#2021-66
GW Properties Wendy's and Guzman Y Gomez –
Preliminary Planned Unit Development
Project Review for Planning and Zoning Commission

<u>Meeting Date:</u>	June 2, 2021
<u>Request:</u>	Preliminary Planned Unit Development two new limited service restaurants.
<u>Location:</u>	5459 and 5501 Northwest Highway
<u>Acreage:</u>	Approximately 2.6 acres
<u>Existing Zoning:</u>	B-2 PUD General Commercial Planned Unit Development
<u>Surrounding Properties:</u>	North: B-2 PUD General Commercial South: M Manufacturing (Three Oaks Recreation Area) East: B-2 PUD General Commercial West: B-2 PUD General Commercial
<u>Staff Contact:</u>	Elizabeth Maxwell (815.356.3615)

Wendy's

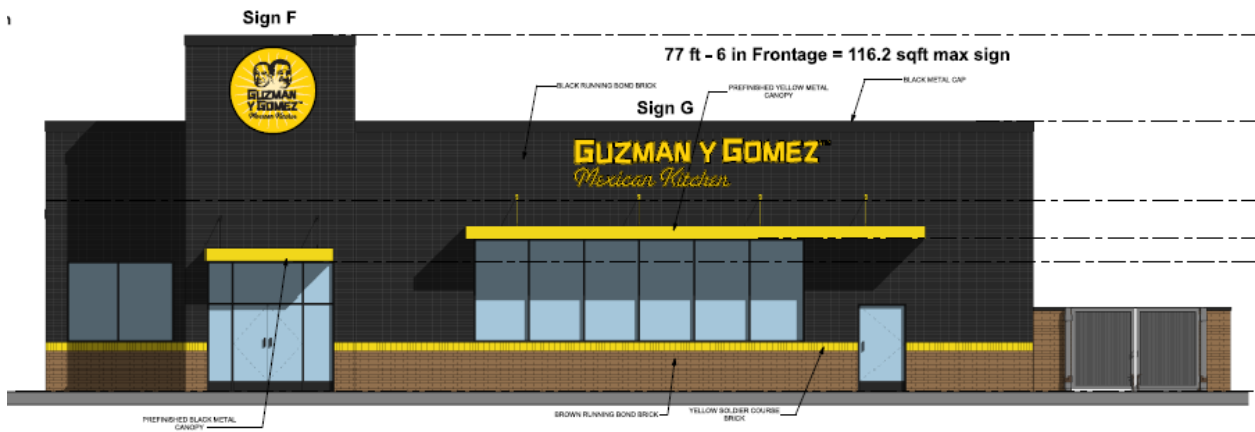
- Wendy's elevations are comprised of a stacked stone and brick. The grey color of the stacked stone is similar in color to the Raising Cane's materials.

- Large bays of windows are proposed around the building and adjacent to the open patio seating. They incorporate a dark anodized frame matching the dark top cap color. The window bays should have a knee wall at the base.

- At the drive-through bays they utilize a dark brick color. This blends well with the Guzman Y Gomez site, but not with the Raising Cane's site.
- A wooden outdoor patio area is along the front of the restaurant. The ability to increase the size of this area or to have a second area closer to the boardwalk should be explored since there is a high demand for outdoor seating.

- The large stacked stone front monument blends well with the other stone around the building and the incorporation of the dark top cap and wood for the patio creates an elegance about the design.

- The proposed LED lighting is recommended to be removed.
- Staff has reviewed the elevations based on the criteria listed in the Design Standards. The project meets 4 of the 10 criteria with two being not applicable. 6 of 10 are required to be considered meeting the design standards for architecture. Several more of the criteria can be met with a few simple changes.

4. Elevations
 - A. Wendy's shall install a minimum 2-foot-high knee wall at the base of all window areas which matches the adjacent thin stone.
 - B. Wendy's to create prominent entry features at the main door on the west elevation.

- C. Wendy's to provide 4-sided architecture for review. Ensure the highest brick covered portion of the building contains some additional details to break up the wall plane.

1 SITE PLAN - OVERALL
 1" = 40'-0"

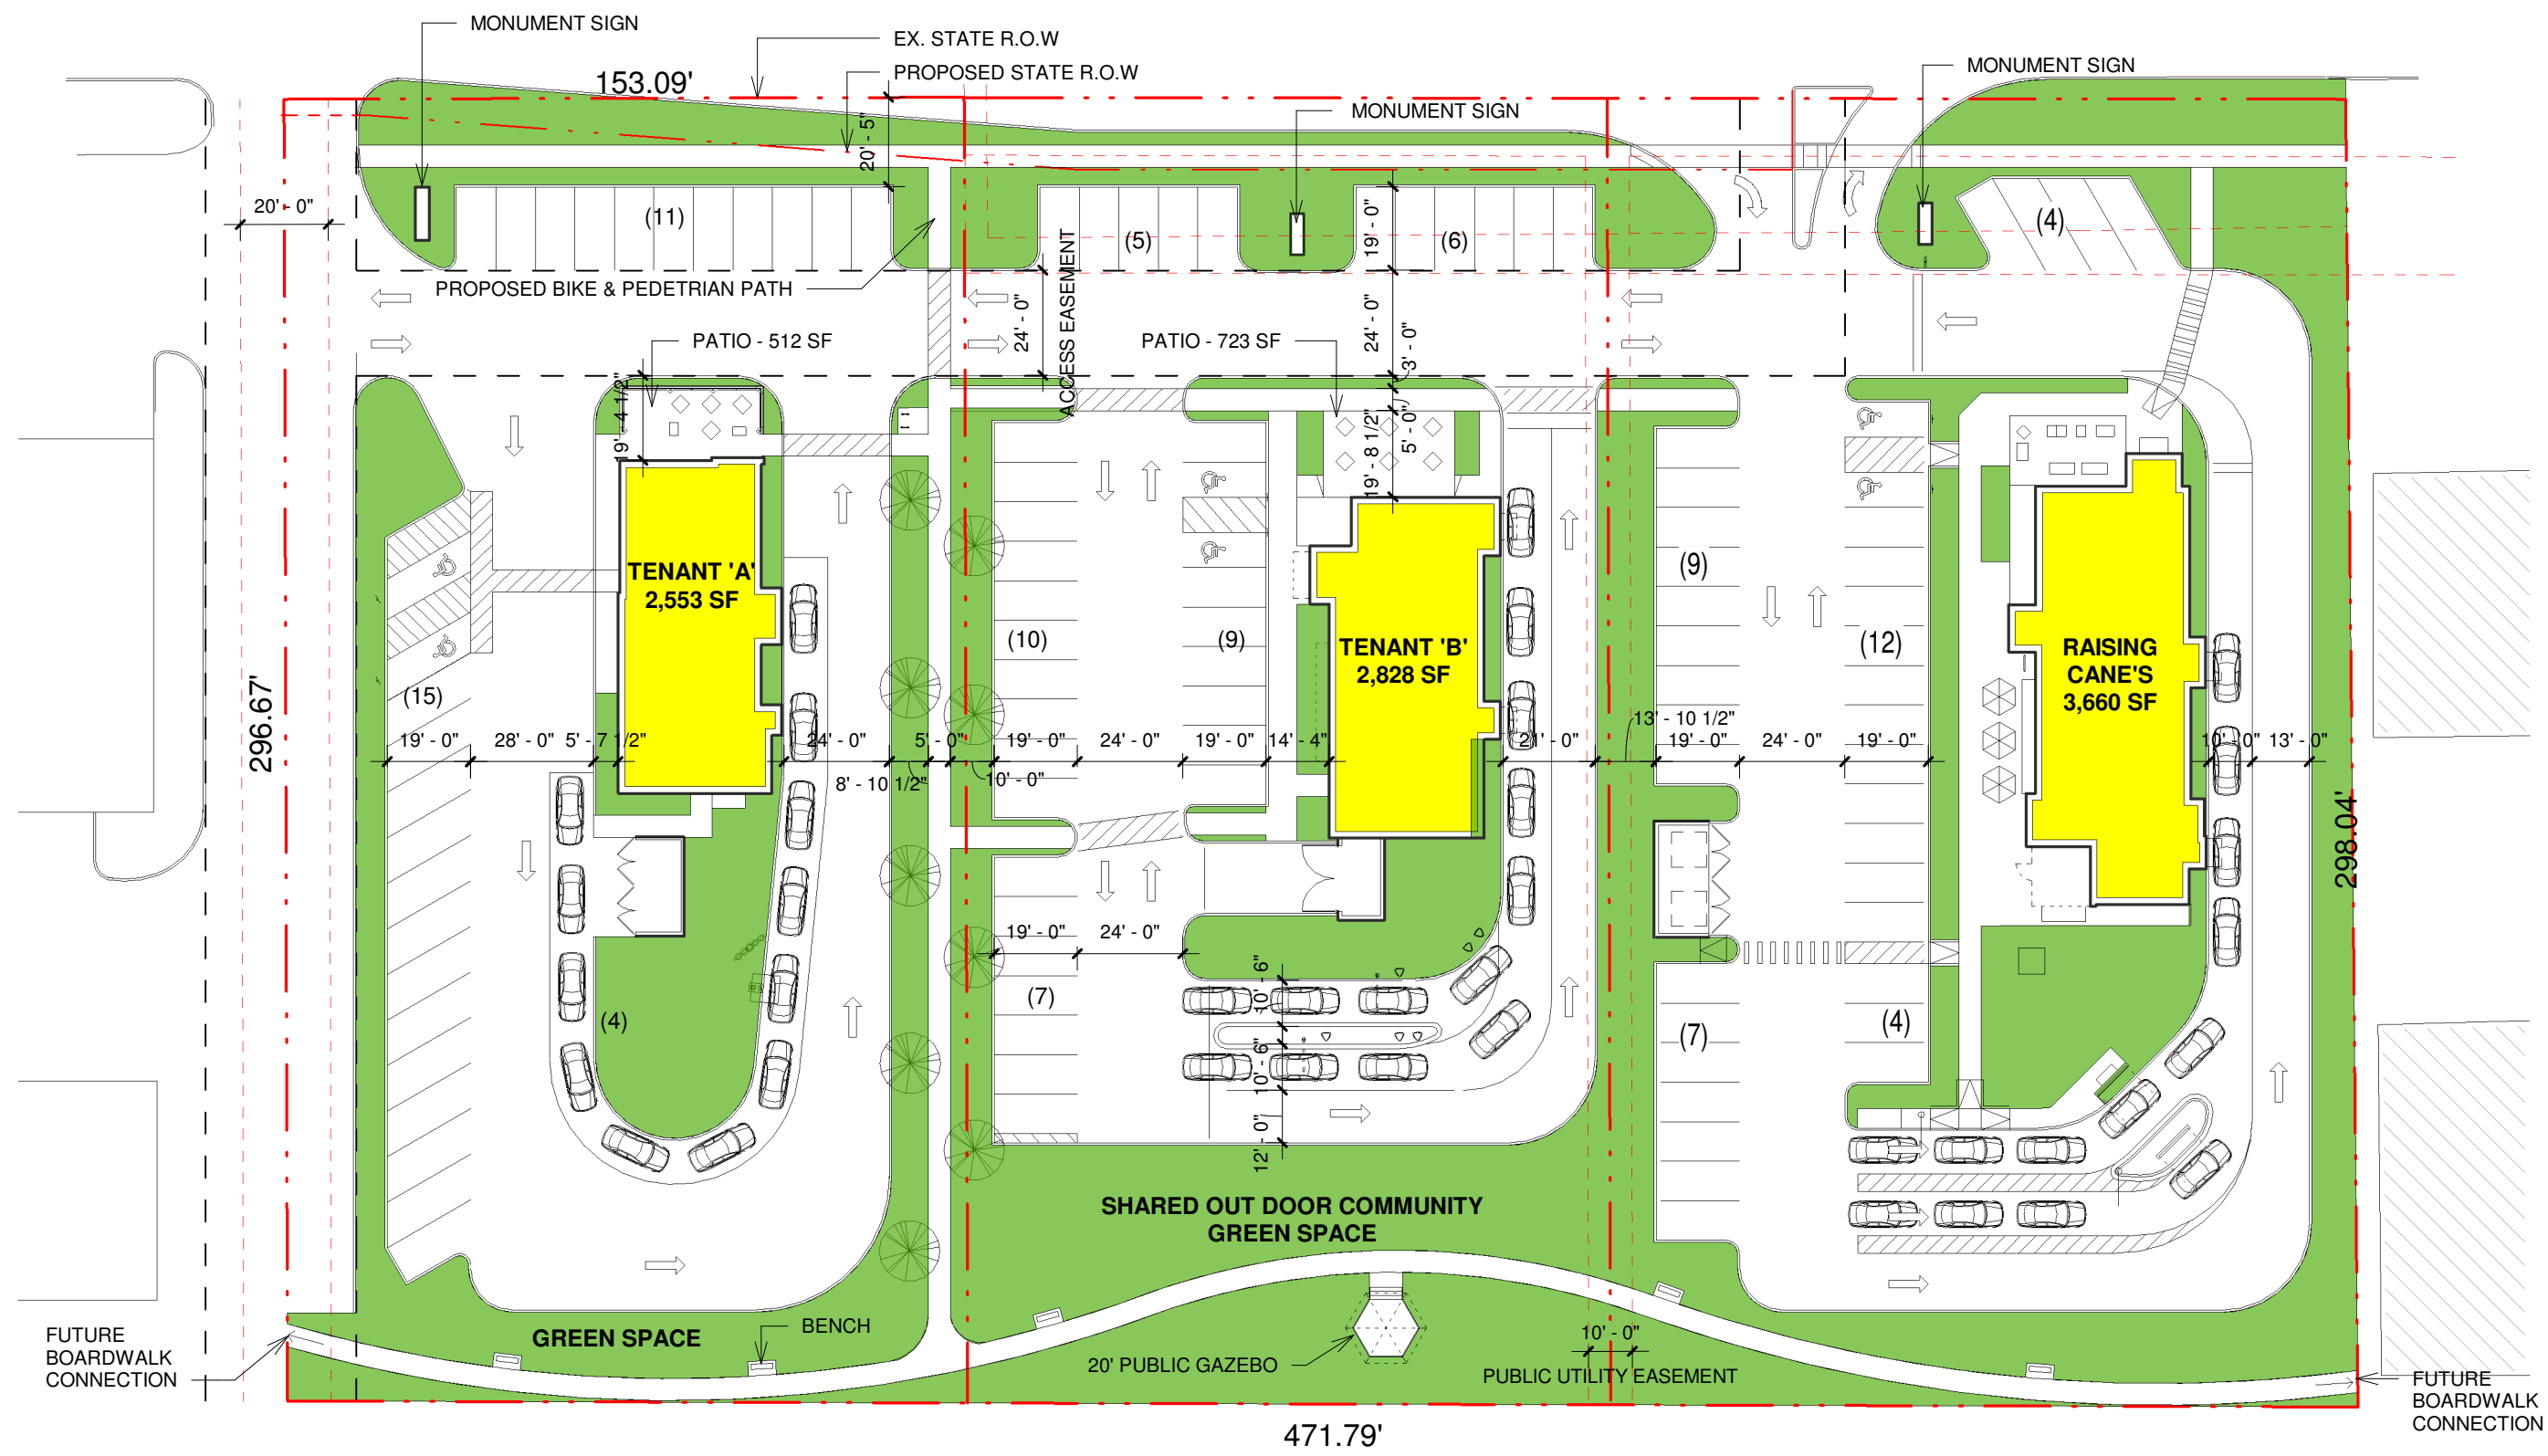
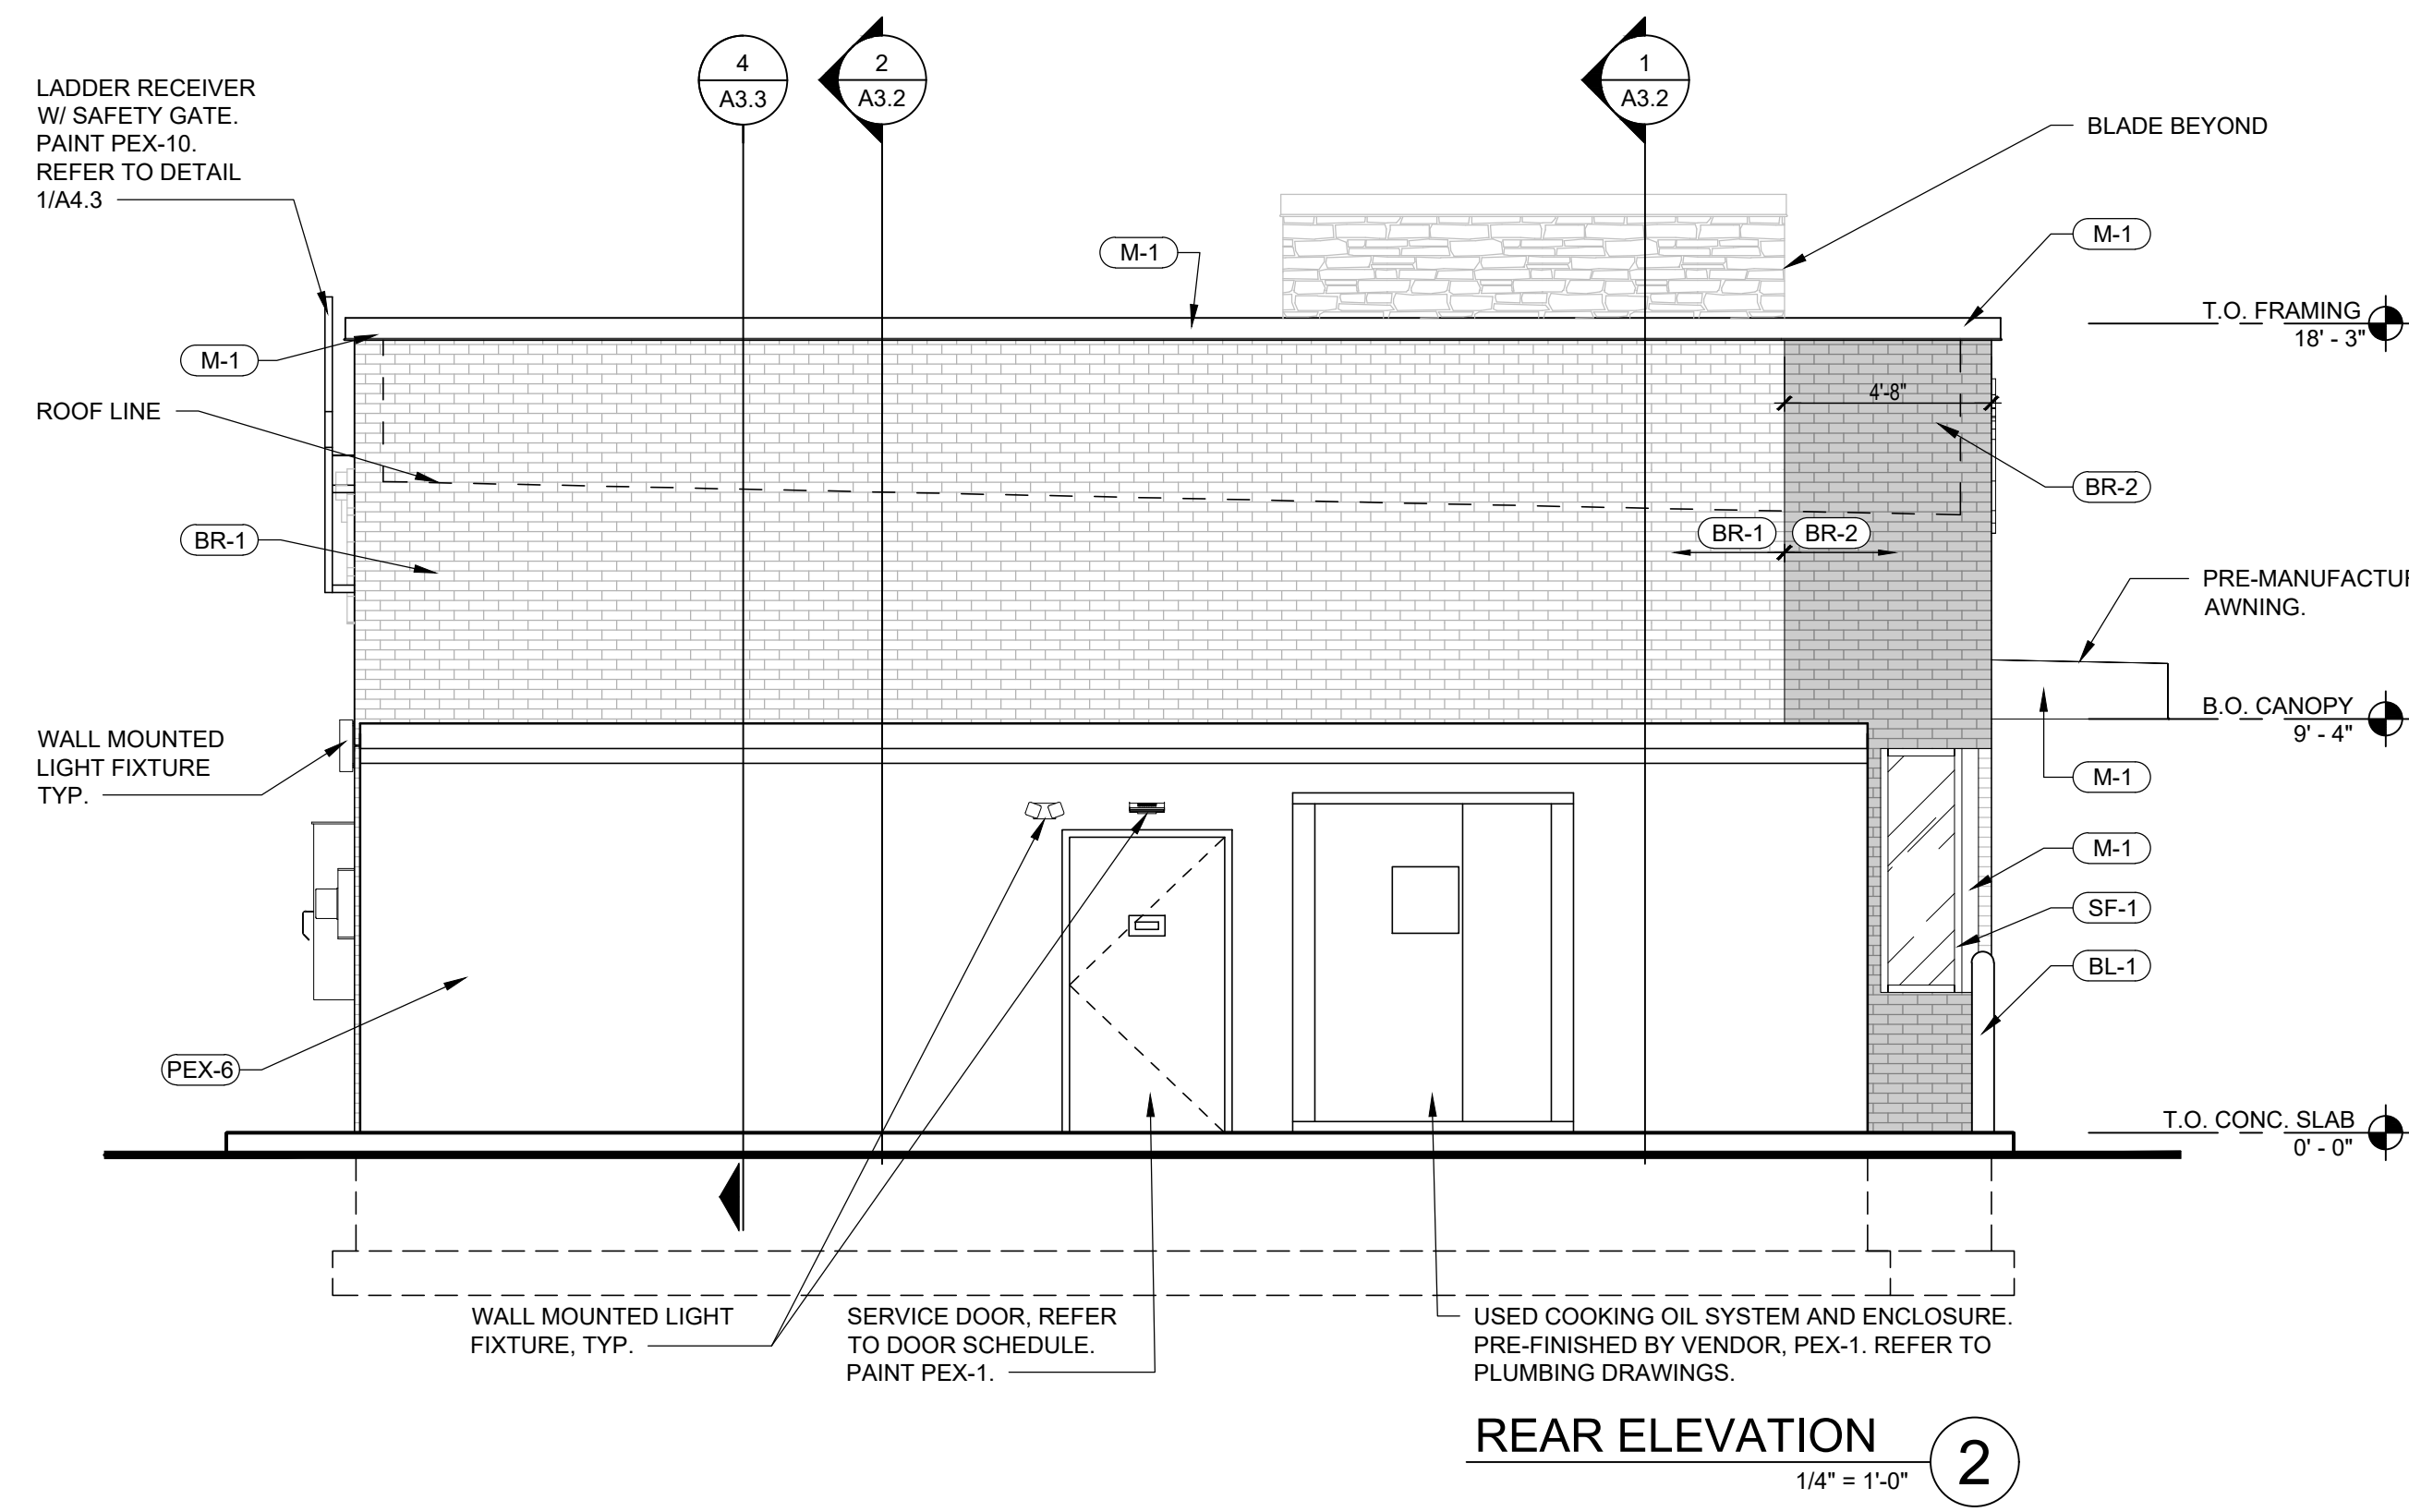
- The site backs to the north lake of the Three Oaks Recreation Area. A future boardwalk is planned behind these lots, which has been illustrated on these plans. Raising Canes has provided a 20-foot area reserved for the future boardwalk. These two lots are also planning for the future amenity with Wendy's providing 20 feet and Guzman Y Gomez providing 57 feet.

- There are two access points into the site from Route 14, one on the Raising Cane's parcel and a shared access between the Wendy's parcel and Cassidy Tire. There is a shared cross access easement among all three properties.

- The Wendy's site illustrates a one-way circulation around the building with a single drive-through lane. There are concerns with the width at the entrance to the site, safety of pedestrians and patrons of the restaurant and seating since it is so close to the drive aisle and the large amount of impervious surface on the site. On site analysis of the access, maneuvering, truck turning movements, pedestrian and cyclist safety, curb cuts, outdoor seating location, and drive-through stacking will be done as part of the amended traffic study.

- Guzman Y Gomez shows two-way circulation for their parking field. This leads to a dual drive-through ordering area and a bypass lane. Two pedestrian crosswalks are shown across the parking lot. Their standard delivery truck and garbage truck can navigate the site. A further on site analysis of the access, maneuvering, truck turning movements, pedestrian and cyclist safety, curb cuts, outdoor seating location, and drive-through stacking will be done as part of the amended traffic study.

- C. The entrance to Wendy's is 40 feet wide, this shall be reduced to provide a slower safer entrance into the site. The landscape island shall be increased up to the needed width of the truck turning movement design. If the driveway cannot be narrowed explore eliminating some parking and adding a second entrance at the south end of the property for larger delivery vehicles.
